This bulletin deals with issues of immediate and significant relevance to all users of Filter Monitor filtration systems in Aviation Fuel service (both Avgas and Jet), including upstream of airport locations. The purpose of this bulletin is to inform current users of all filter monitor filtration systems of:

EI 1583 7th edition

Filter monitor phase out roadmap

Appendix 3 - Comparison of 60 and 100 mesh sizes for strainers

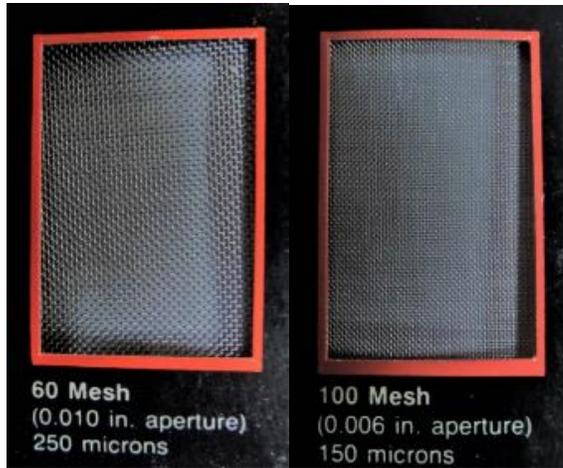
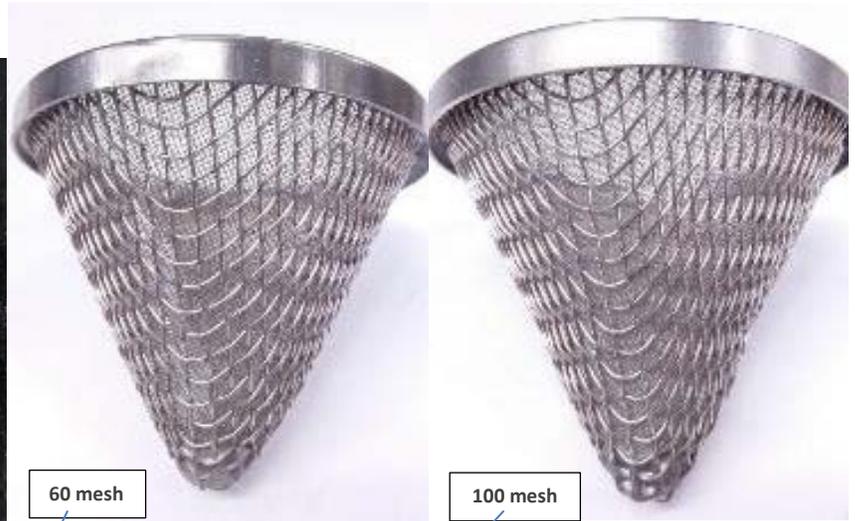
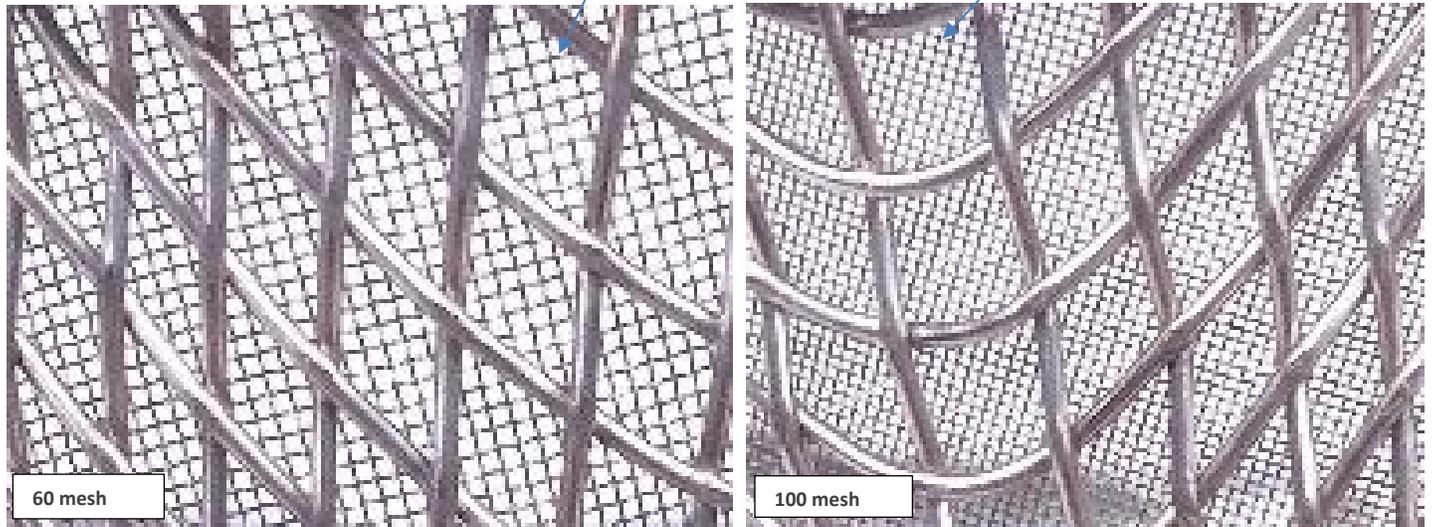
- On vehicles fitted with filter monitors where the hose-end strainer will change from 60mesh to 100mesh, as defined in the table of actions below, it is recommended that each venturi circuit is checked and re-adjusted, if necessary, during the next scheduled check of the PCVs (for compensated systems)

5	Adjust the activation point of DP switches currently fitted on all filter monitor vessels to 15psi (1.0 bar), in accordance with the equipment manufacturers' procedures.	JS	31/1/2018
6	If not already in place, change all hose-end strainers on fuelling equipment fitted with filter monitors to 100 mesh size.	JS	31/1/2018
7	All 2" filter monitor elements in service shall be compliant to EI 1583 7 th edition	JS	30/6/2018
8	All 6" Out to In (direction of flow) filter monitor elements in service, that cannot be converted to an EI 1581 6 th ed. FWS, shall be compliant to EI 1583 7 th edition. Note: If the due date cannot be met due to limited supply options of EI 1583 7 th ed. 6" elements, a revised due date will be considered by JIG in a future JIG Bulletin.	JS	30/6/2018
9	Regardless of their element flow configuration, all converted filter monitor systems (i.e. converted from a previous FWS configuration) with 6" filter monitor elements shall be re-converted to EI 1581 6 th edition FWS, with advice from the filter manufacturer	JS	30/6/2018

(6) See also Appendix 3 in this Bulletin
